ADDENDUM NO. 1

March 22, 2023

227991

**RE: WHOLE VILLAGE FAMILY RESOURCE CENTER
 PARKING LOT REPLACEMENT**

C3

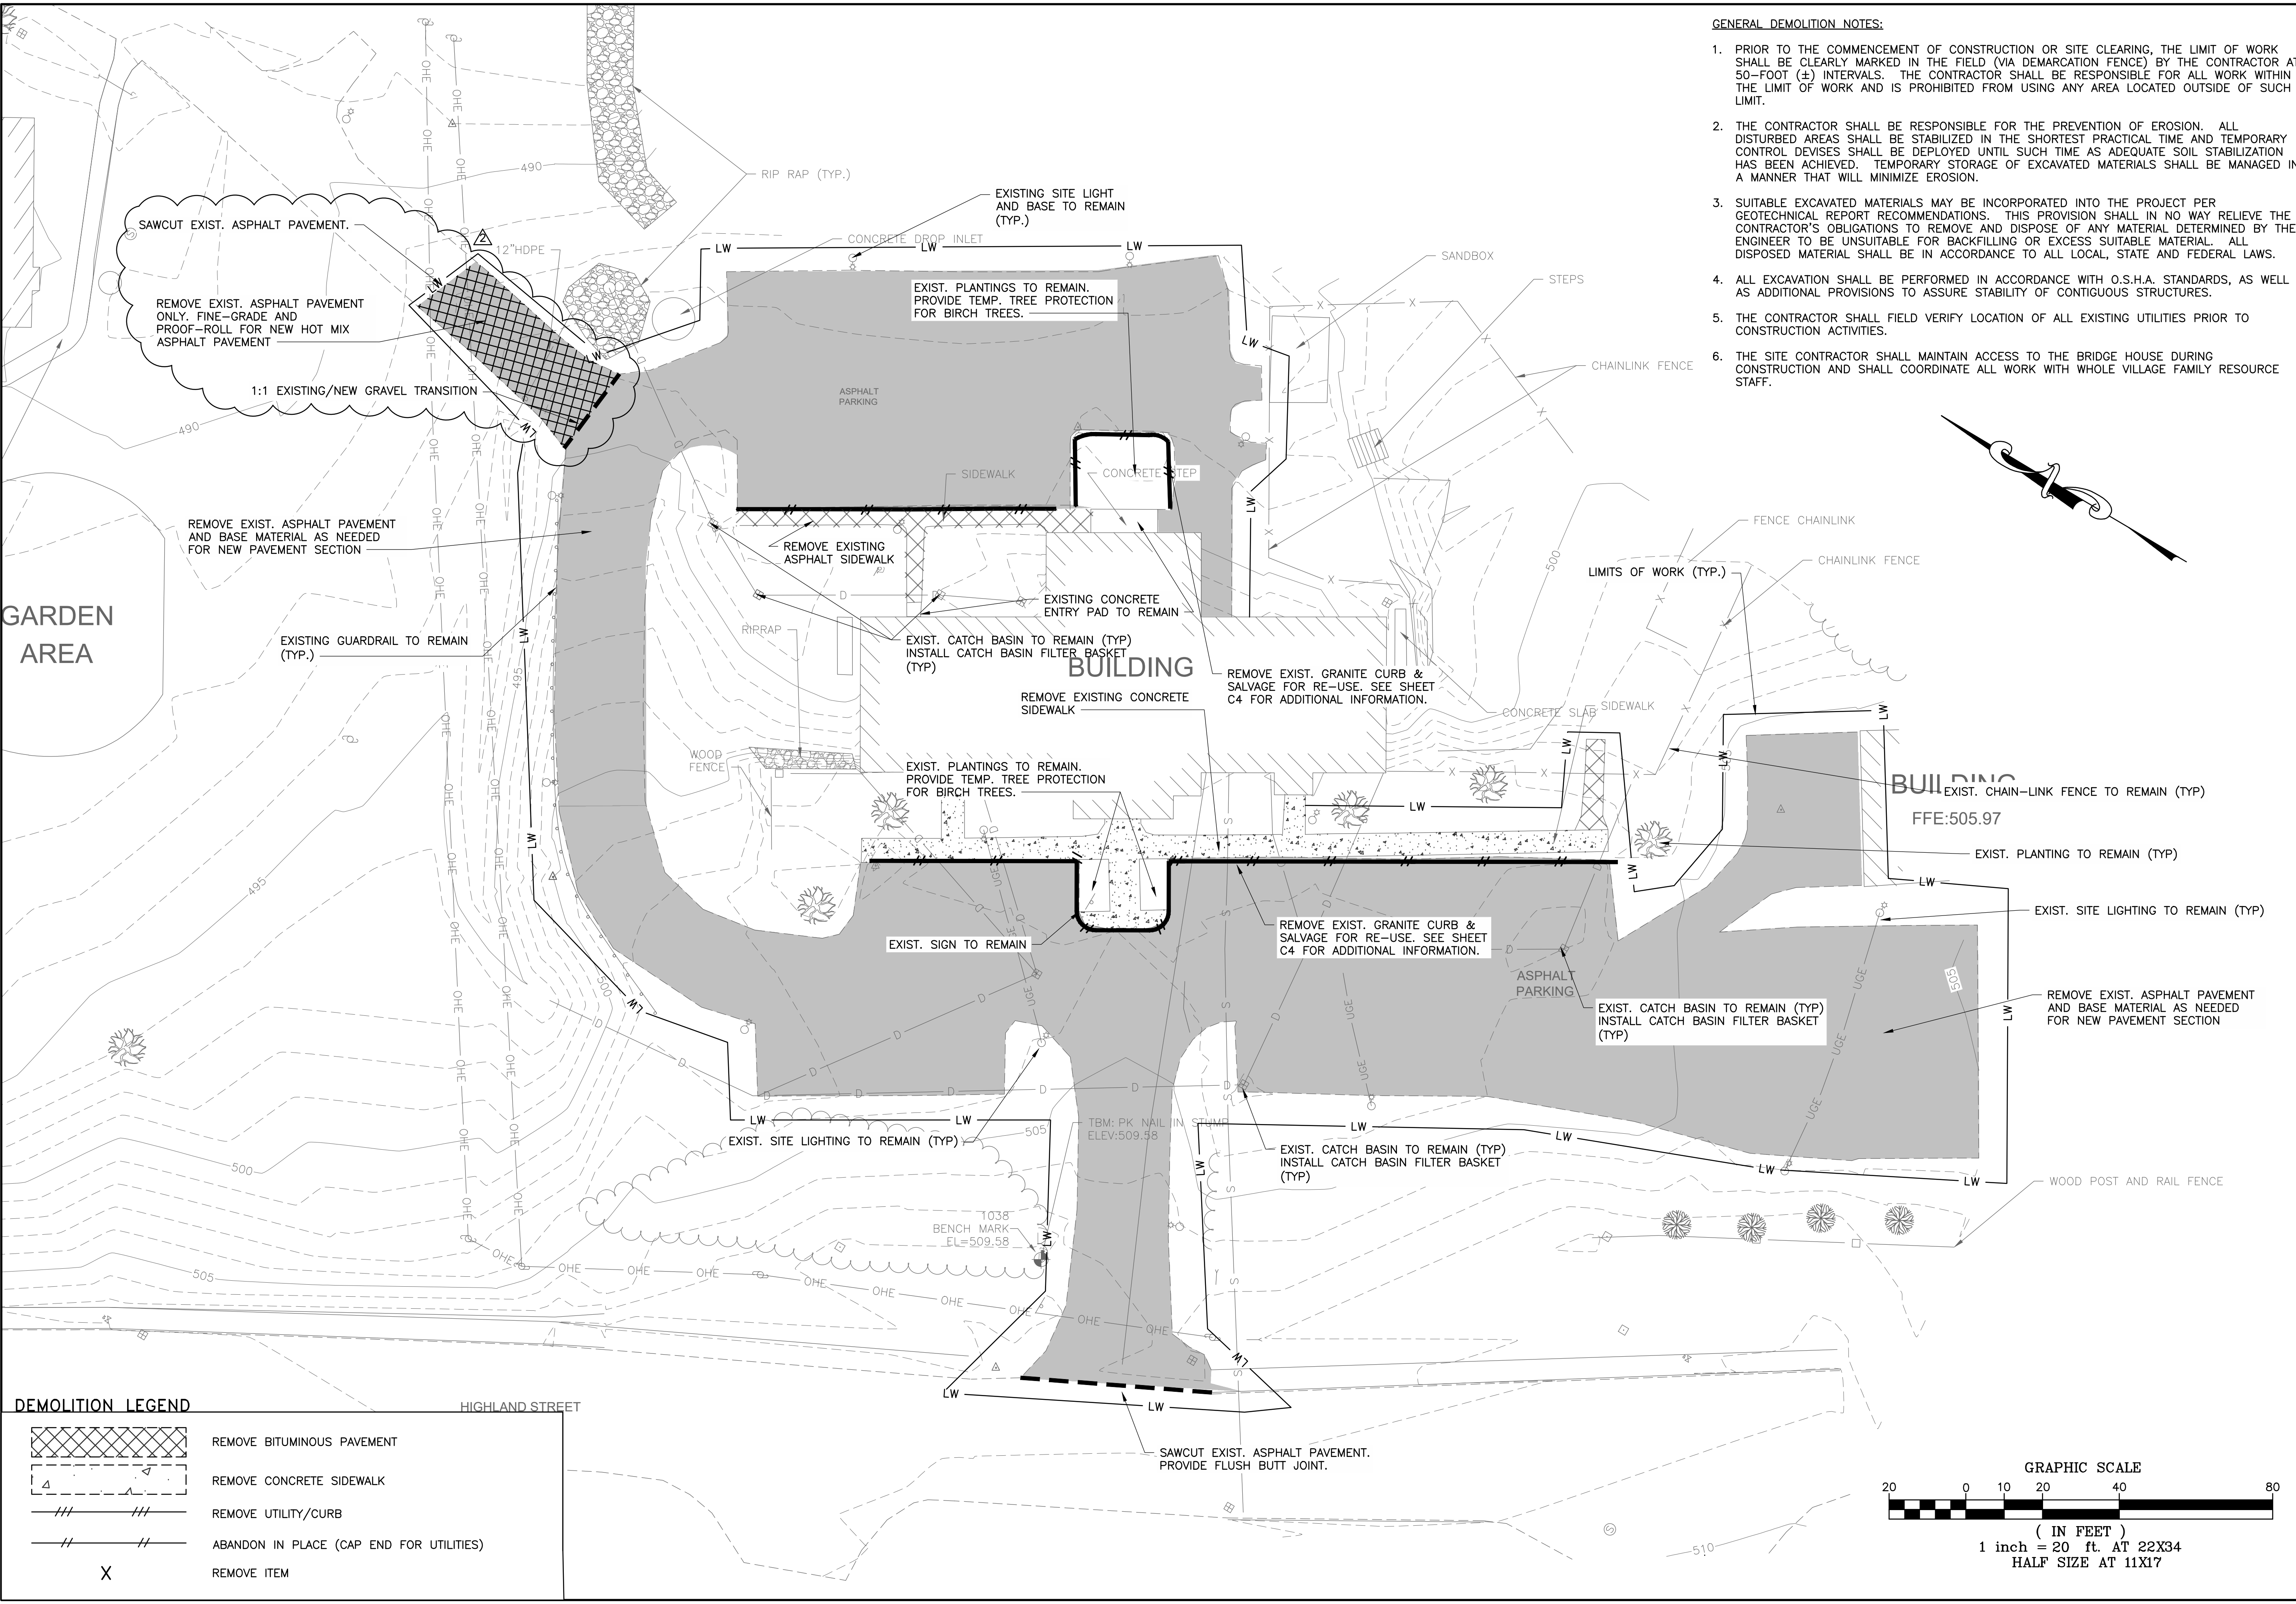
1. **Sheet C3** – Topographic Survey. Add drawing to bid set.
2. **Sheet C4** – Site Removals Plan. Remove and replace in its entirety.
3. **Sheet C5** – Site Layout Plan. Remove and replace in its entirety.
4. **Sheet C7** – Site Details. Remove and replace in its entirety.

CONCRETE SIDEWALK w/ VERTICAL GRANITE CURB DETAIL
NOT TO SCALE

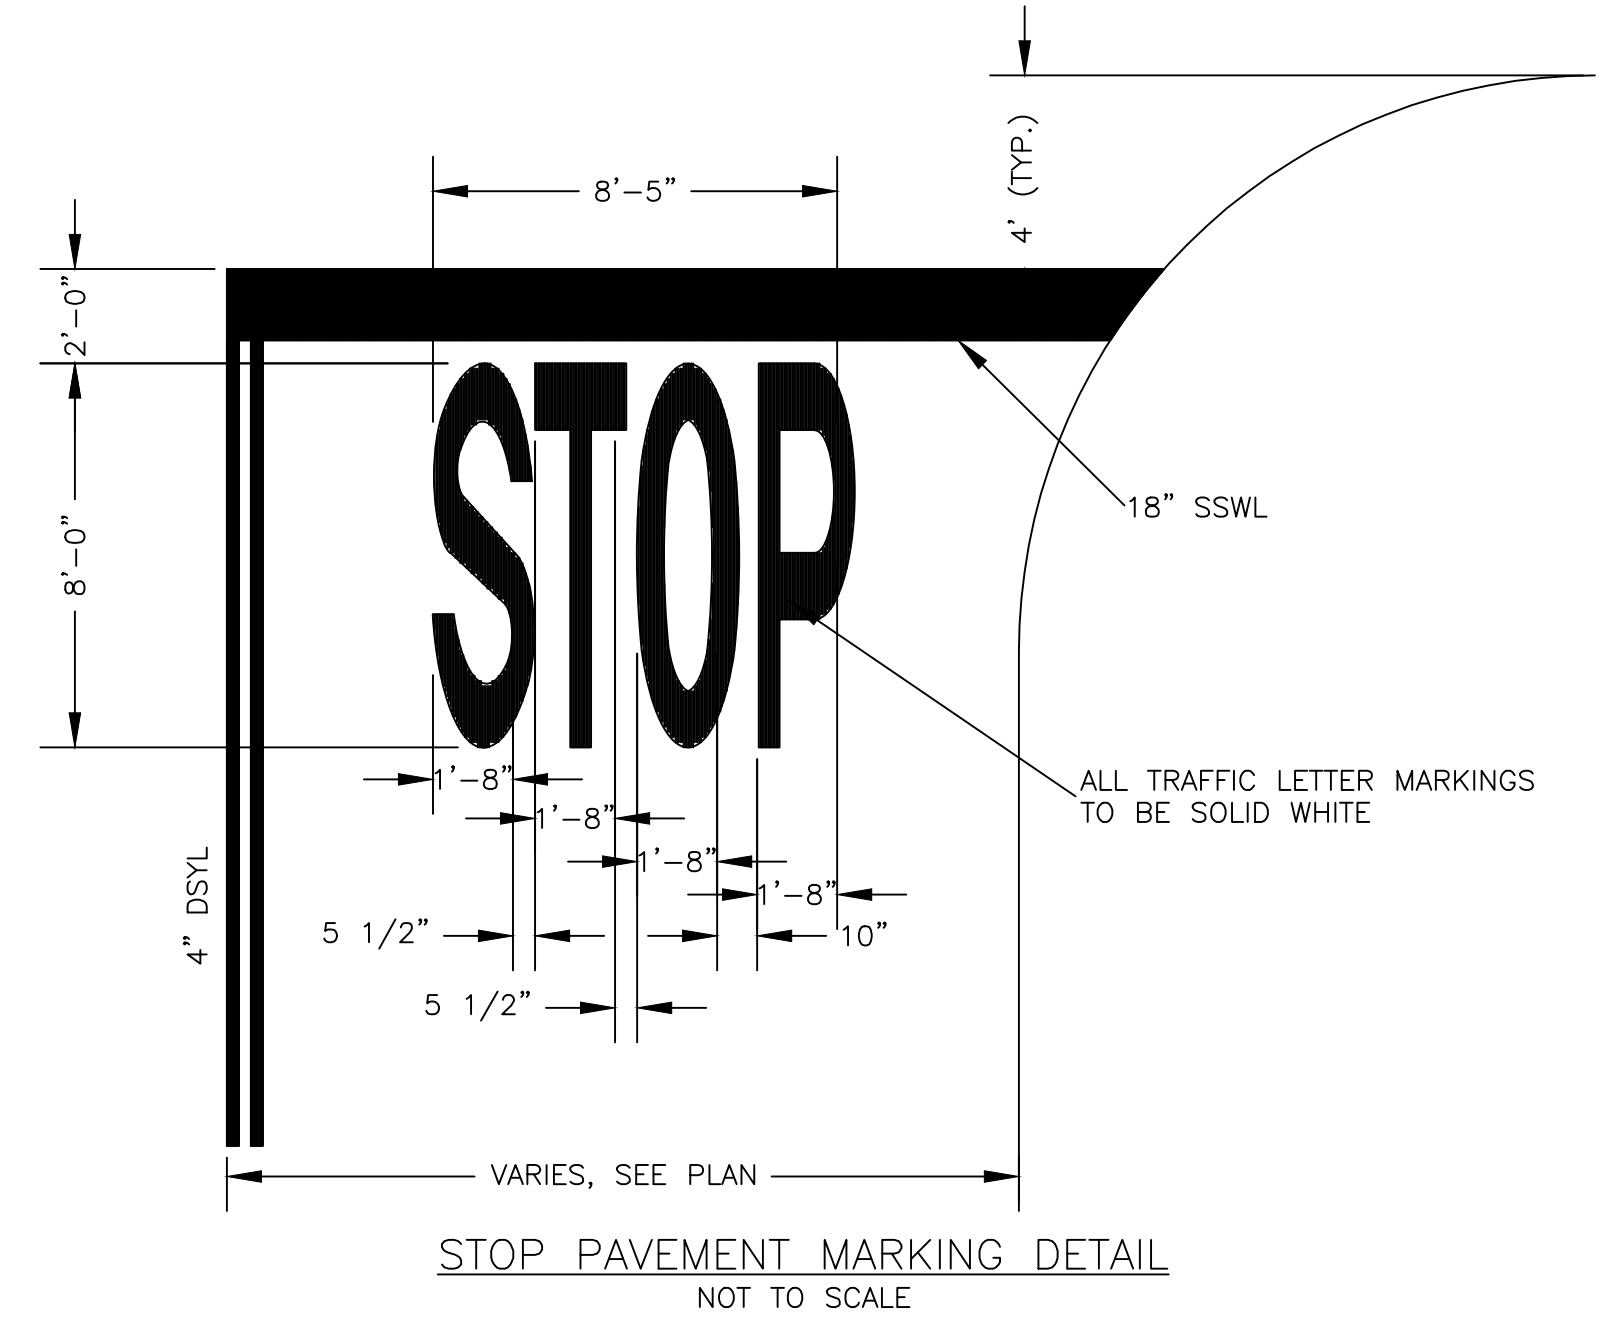
- 4. The sidewalk detail shows insulation. Will this be required?**
Insulation will be required below CIP concrete sidewalk.
- 5. For compliance with BABAA, does every item require a certificate?**
Contractor shall include Manufacturer's Certification for BABAA requirements with all applicable submittals.

PARKING LOT PAVEMENT DETAIL
NOT TO SCALE

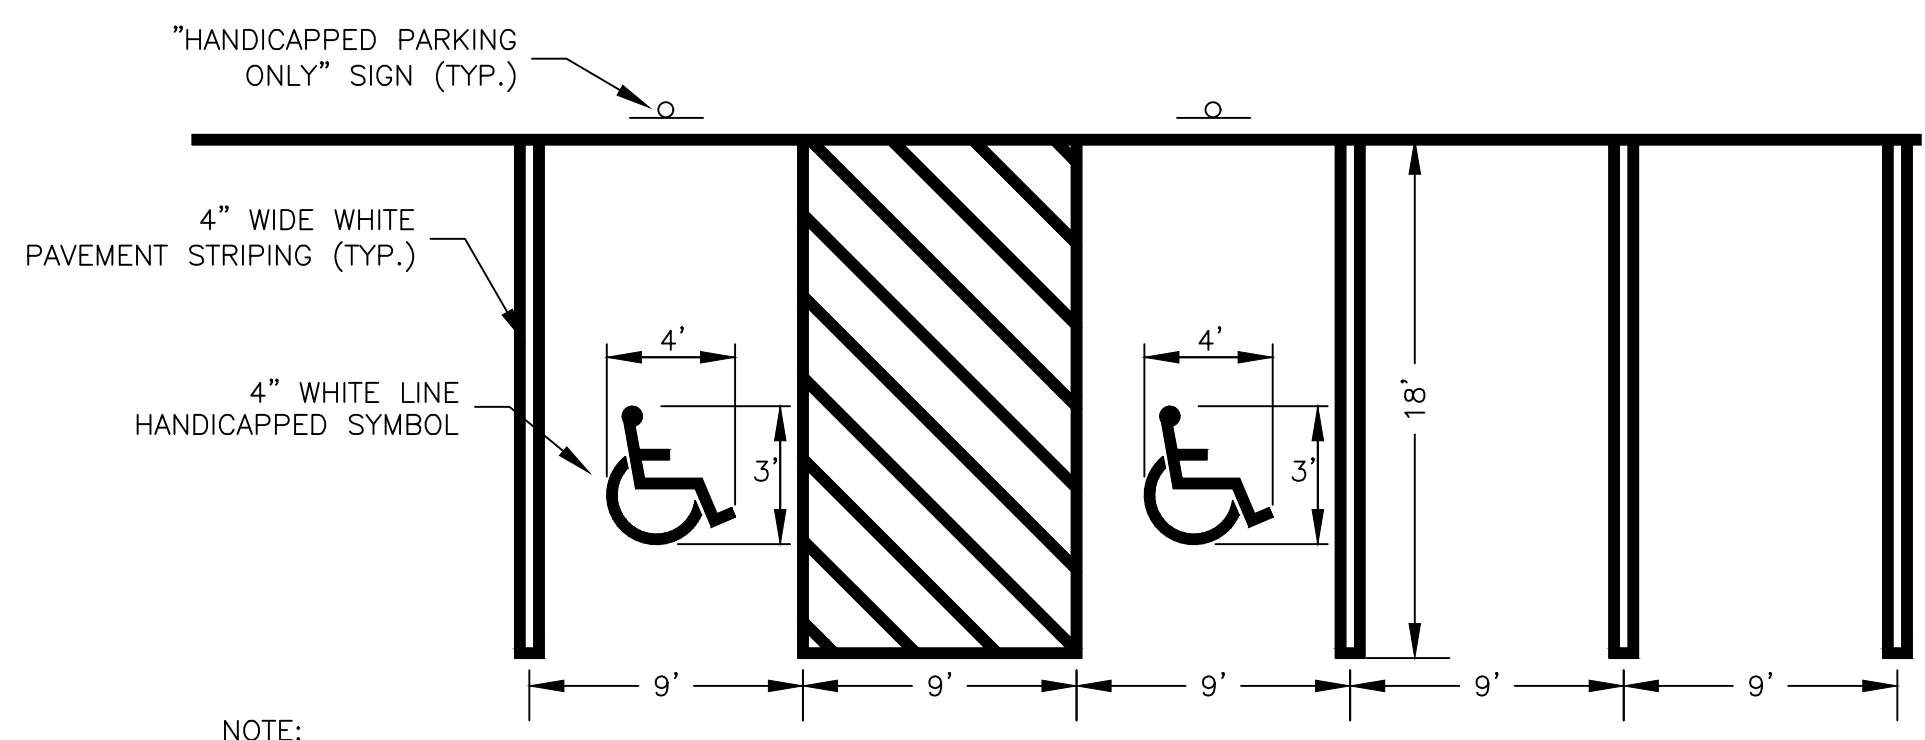
- 2. Is a SWPPP required?**
There will be less than 1 acre of disturbance. Therefore, a SWPPP will not be required.
- 3. Is NHDOT 304.4 an acceptable substitute for base gravels?**
See revised sheet C7. NHDOT 304.4 shall be used for gravel base course and NHDOT 304.5 shall be used for gravel sub-base course.
